Groundwater & Wastewater Services: Septic Project File & D

IMPROVEMENT PERMIT/CONSTRUCTION AUTHORIZATION for REPAIRING an ON-SITE WASTEWATER TREATMENT & DISPOSAL SYSTEM

Job Location Address: 8701 Plaza Park Dr.

OPERATION PERMIT for an ON-SITE WASTEWATER TREATMENT & DISPOSAL SYSTEM

SKETCH OF SYSTEM LAYOUT
(Proposed Layout)

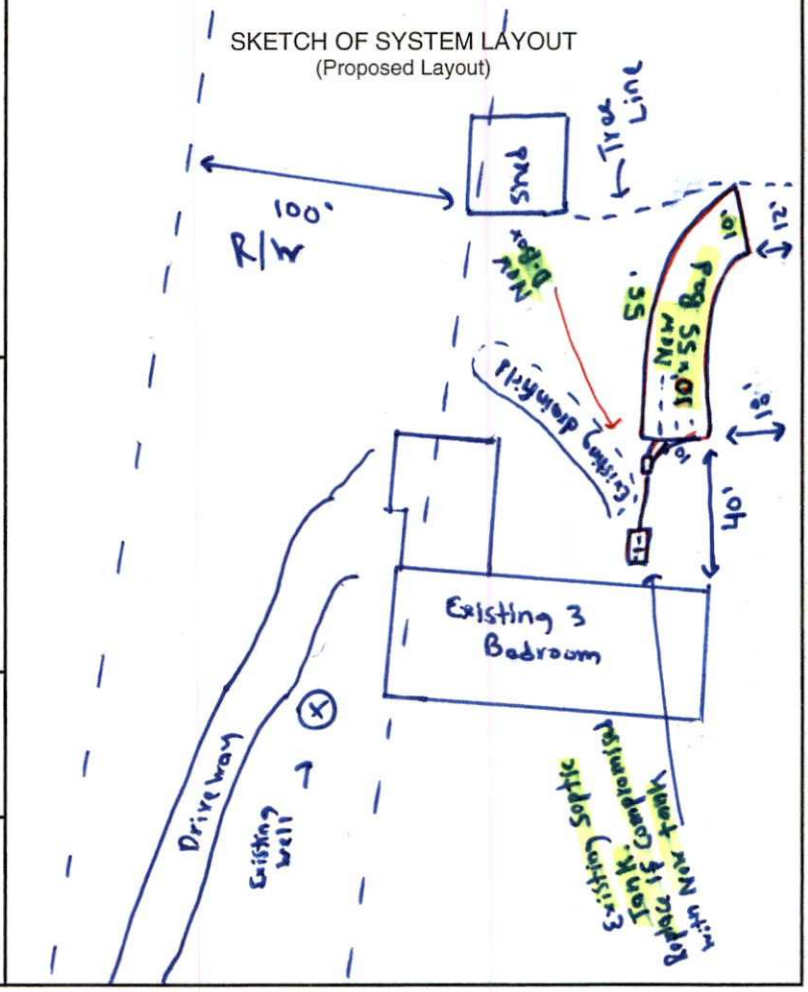
10-12 ft x 50-55 ft drainfield Bed (2 ft gravel), New D-Box, New tank * if Existing tank is Compromised.
R/W takes up majority of yard.

SKETCH OF SYSTEM INSTALLATION
(As-Built Drawing)

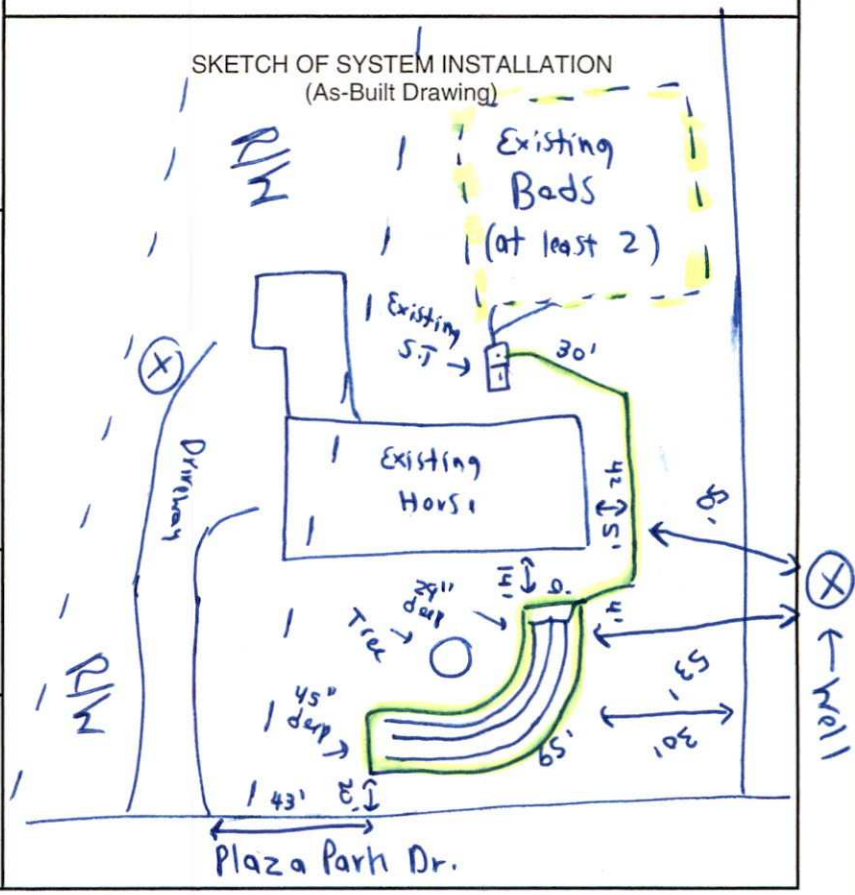
Comments: System Classification & Type: IIIg CHM-36 New 9' x 65' Beds in front yard (3- Infiltrator Quick-4 Lines) Existing septictank is still connected to existing Beds in the back yard. Gravity fall has achieved for new bed.

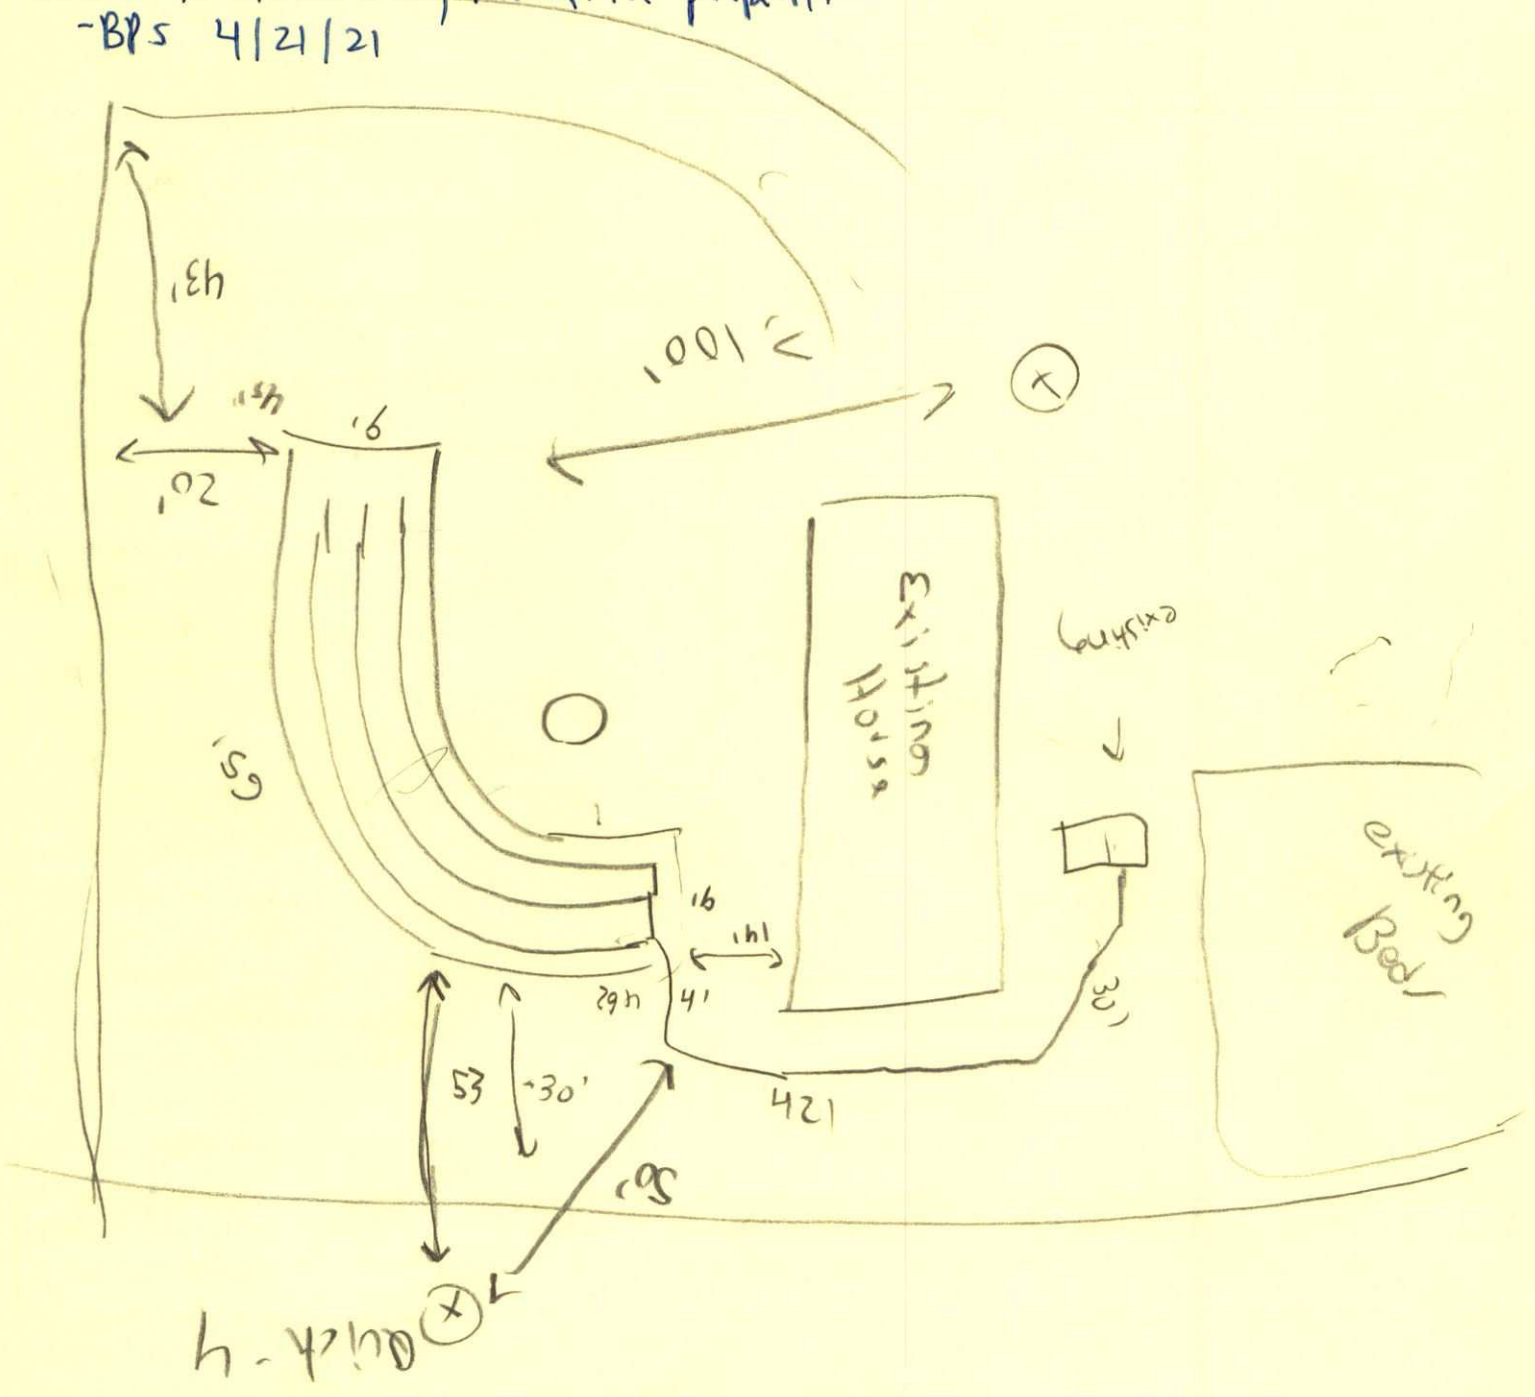
- Permitted Bed in the backyard was unable to be installed, due to another existing bed being discovered. Therefore, the soil was evaluated in the front yard, and we were able to get a gravity fed bed in the front yard. 1 Suitable soil. front yard was the best option. since the backyard, has several drainfield beds already, also Large R/W cutting through the property.

V. Other: Existing septic tank (in good condition) is still connected to the two existing bed(gravel) in the back yard. New 9'×65' bed in the front yard.
